DANE COUNTY DEPT. OF PUBLIC WORKS, HIGHWAY & TRANSPORTATION

ADDENDUM

RFB NO. 320038 - ADDENDUM NO. 02

DANE COUNTY SHERIFF'S SE PRECINCT REMODEL AND ADDITION

All reports, plans, specifications, computer files, field data, notes and other documents and instruments prepared by OPN Architects, Inc. as instruments of service shall remain the property of OPN Architects, Inc. OPN Architects, Inc. shall retain all common law, statutory and other reserved

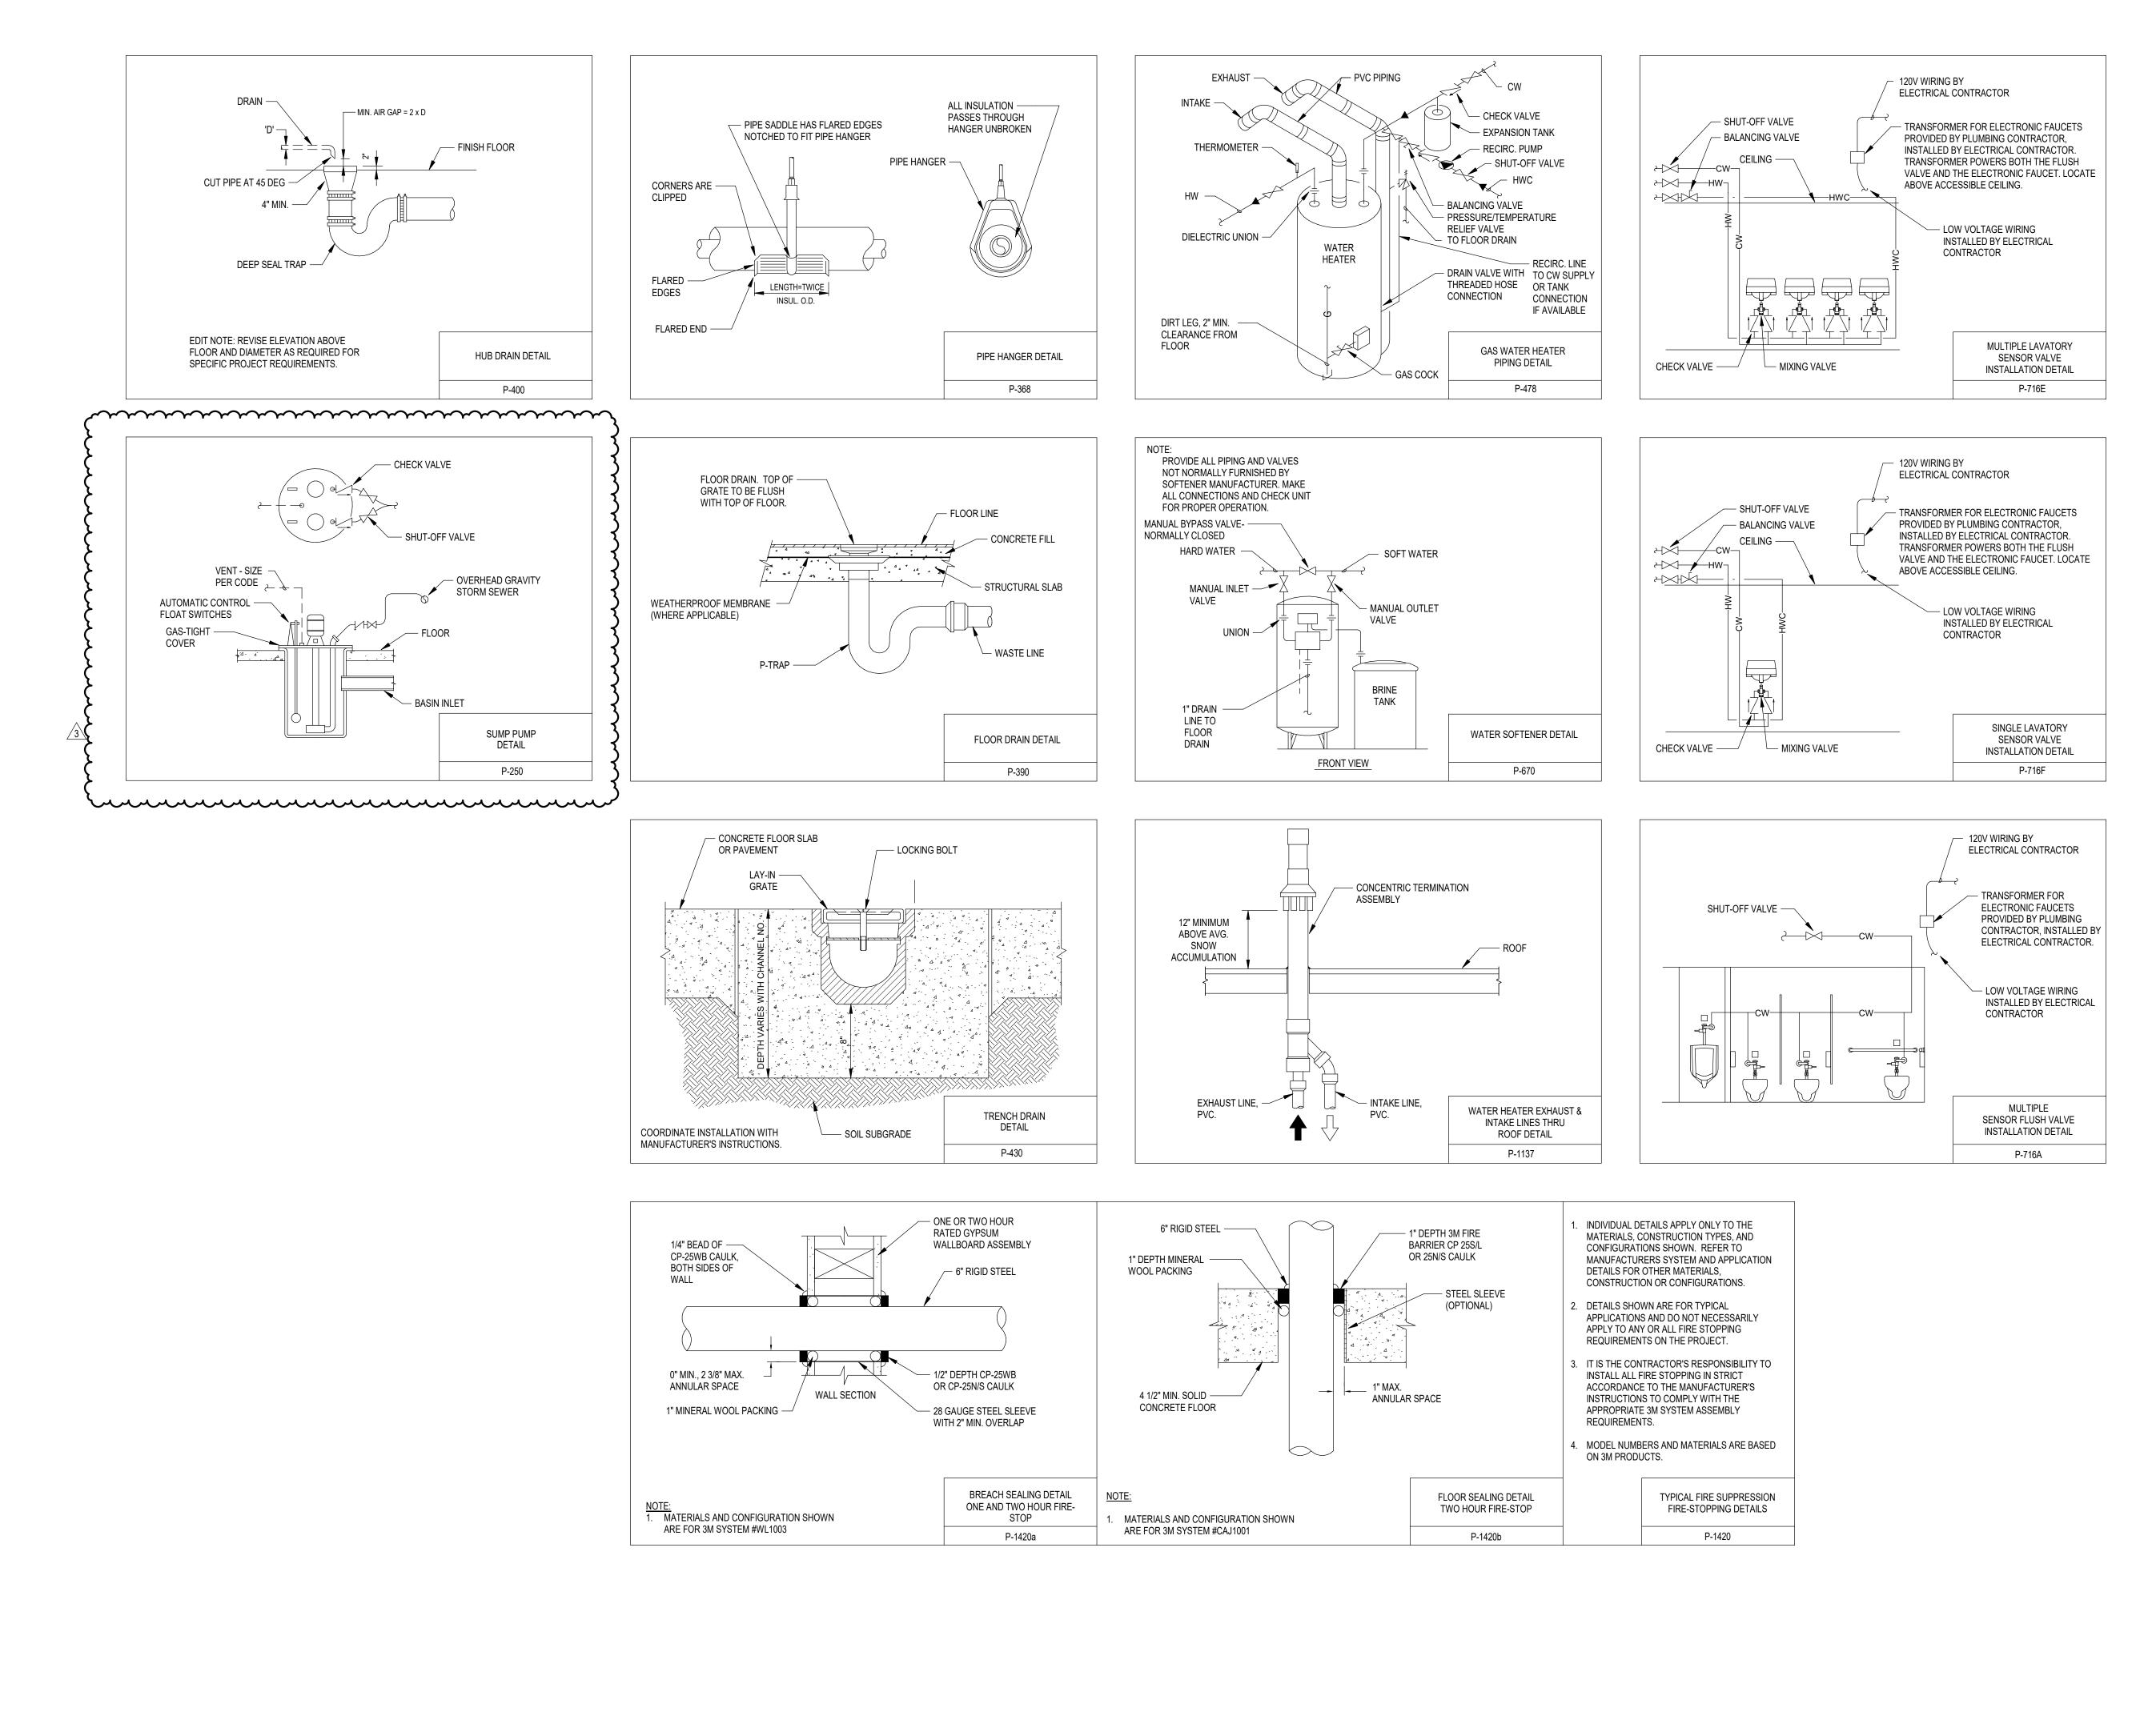
41. Sheet P101

Modify current Sheet P101 as shown on Drawing 1 as follows and issued with this Addendum:

- a. Modify to reduce the amount of sanitary waste piping upstream of the grease interceptor per request of the plumbing plan reviewer.
- b. Add storm piping and sump pump to serve trench drain shown on Civil plans and discharge above grade.

H500

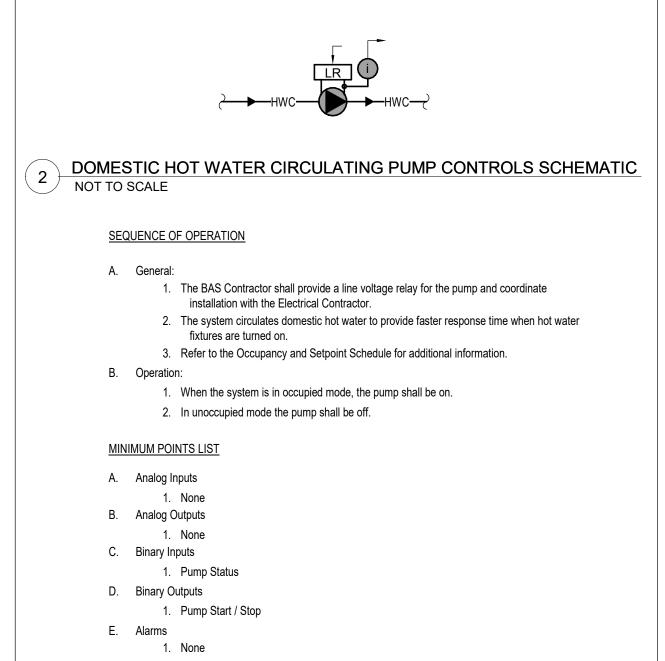
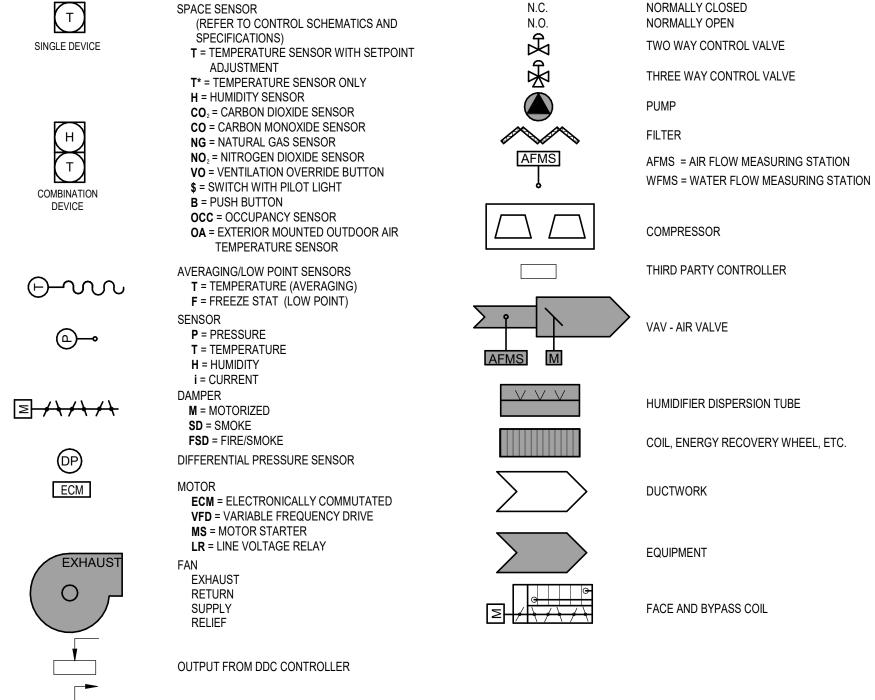
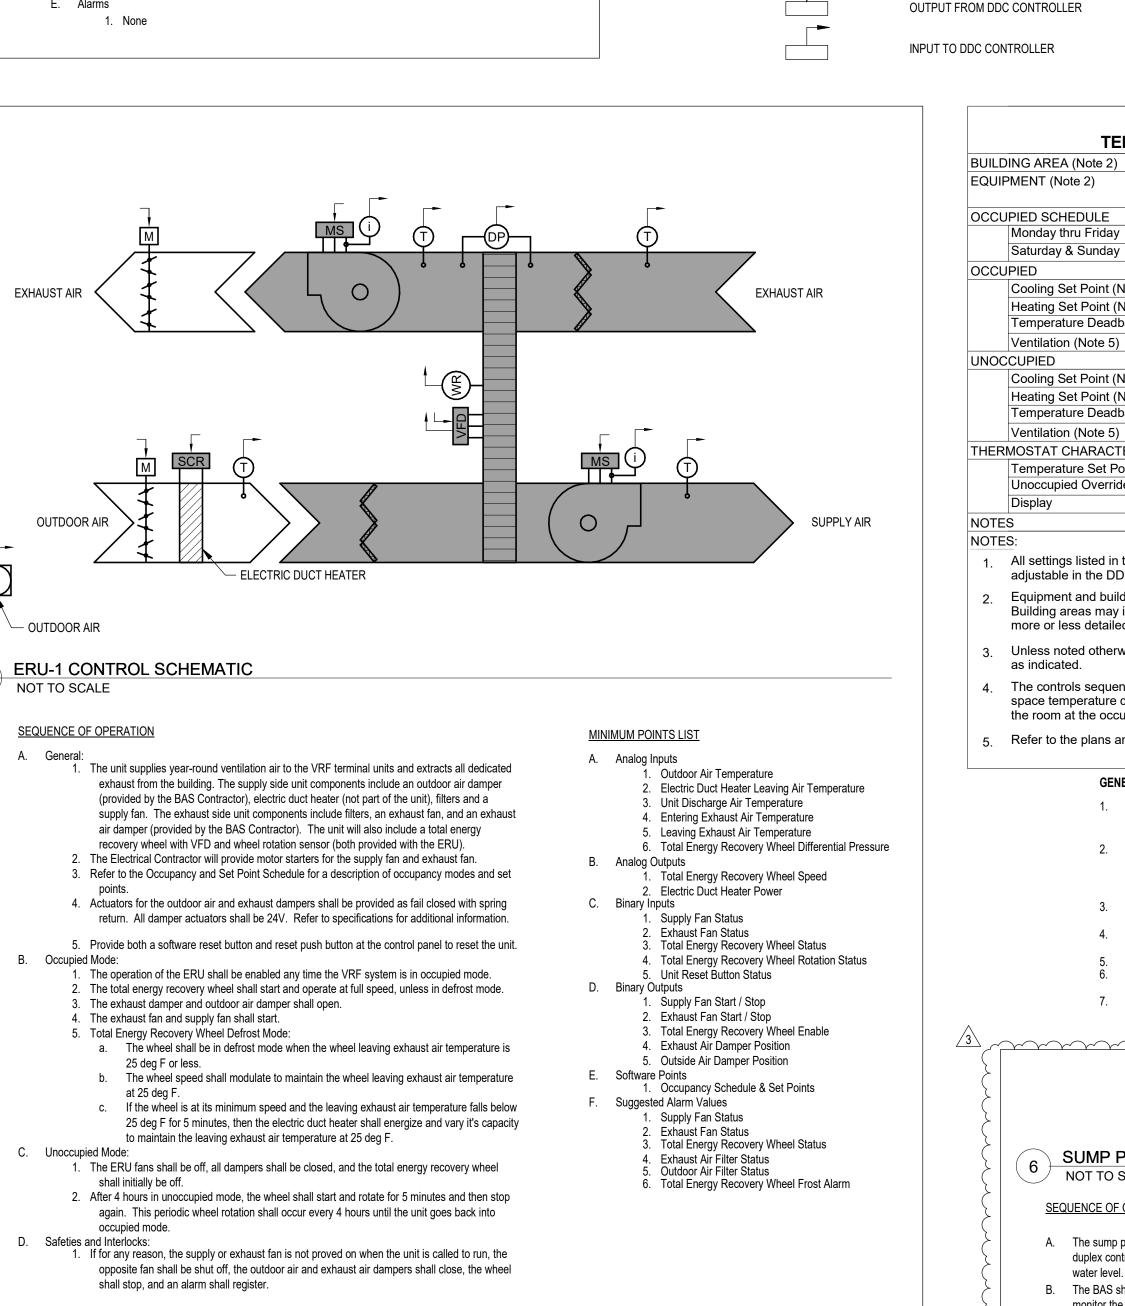
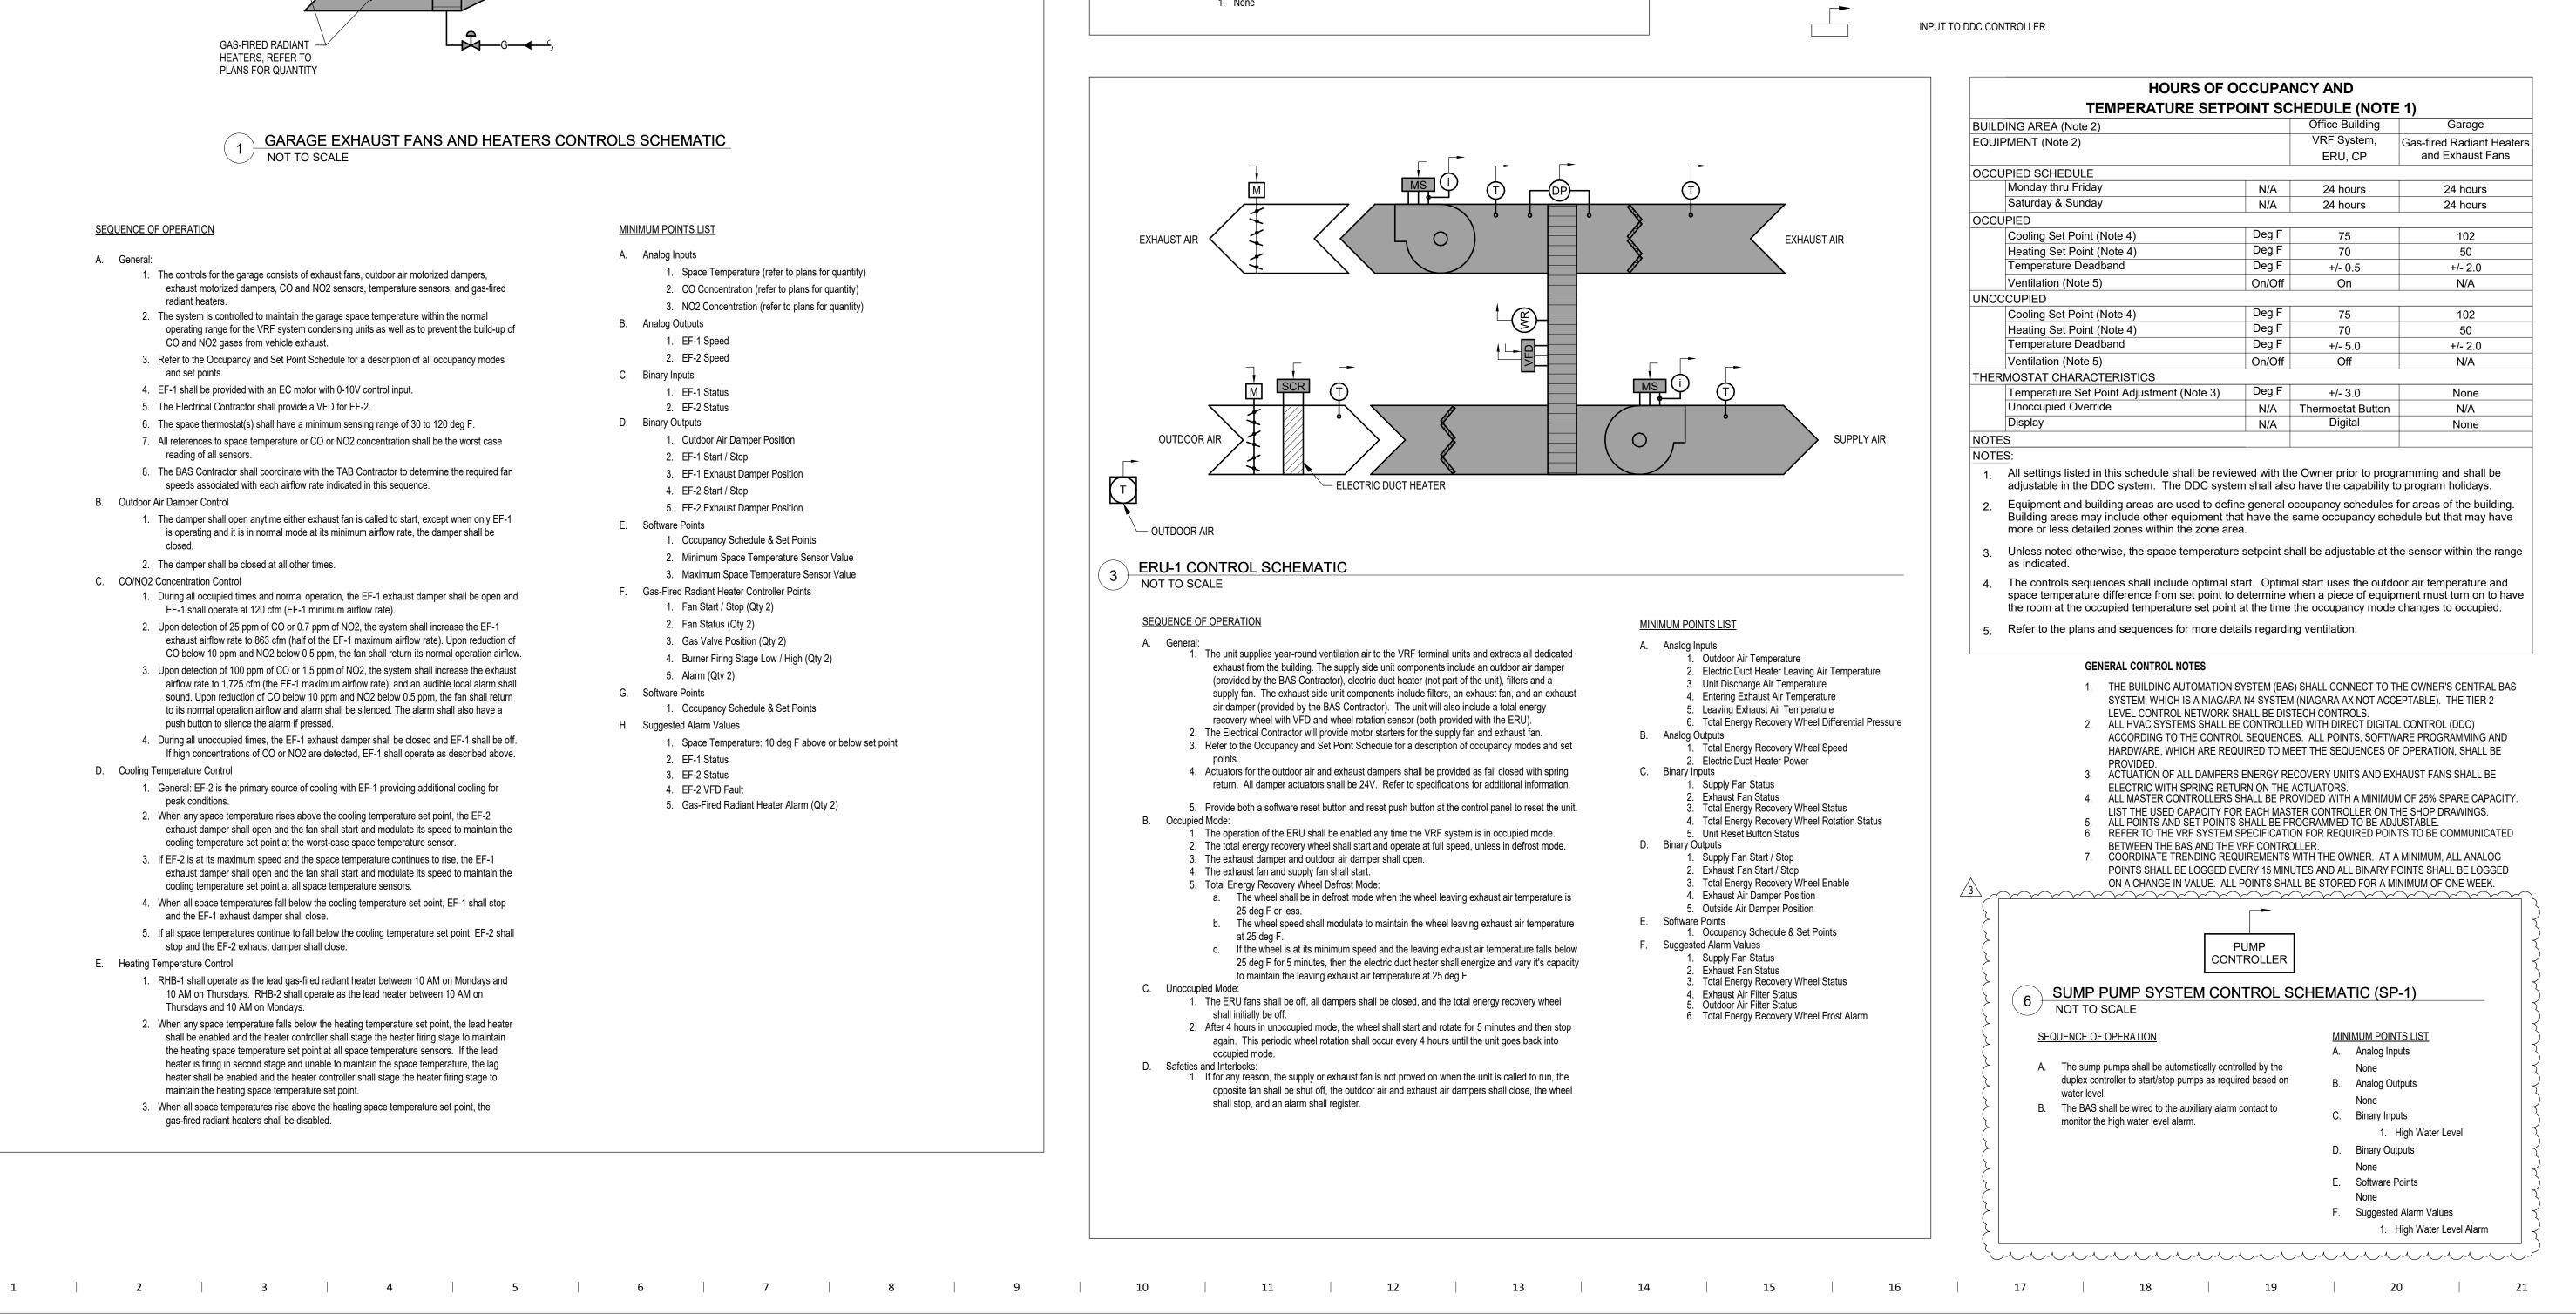
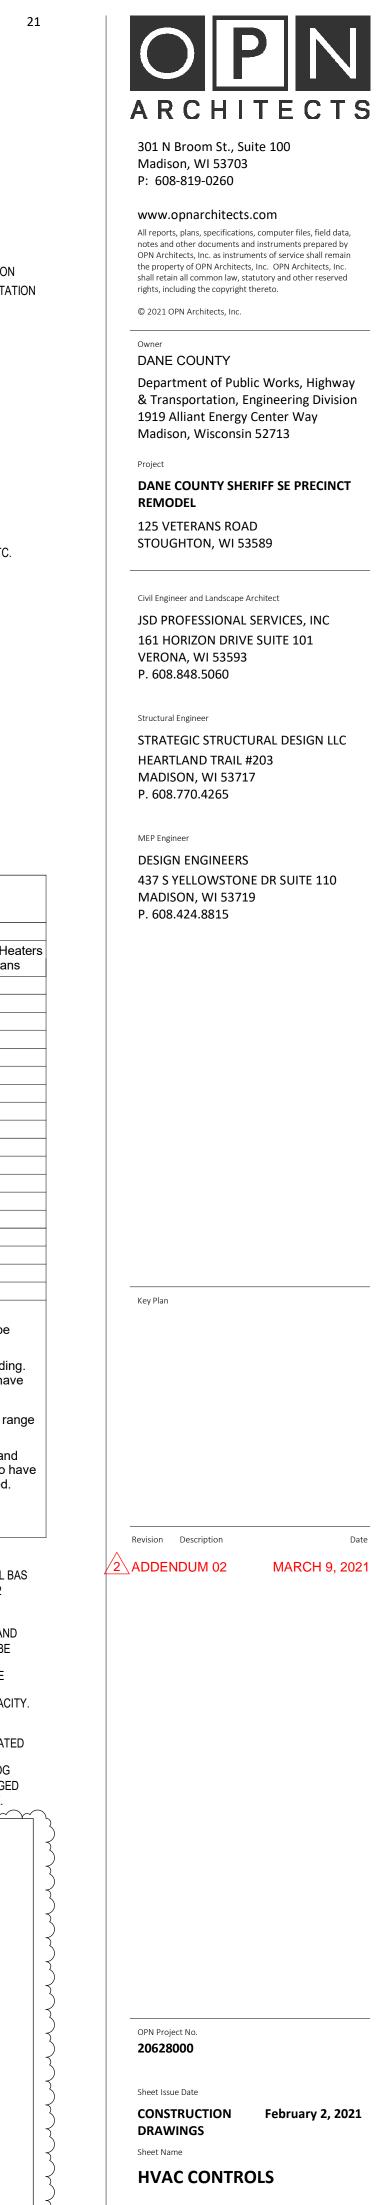
45. Sheet H500

Modify current Sheet H500 as follows and issued with this Addendum:

a. Add Sump Pump Controls Schematic.
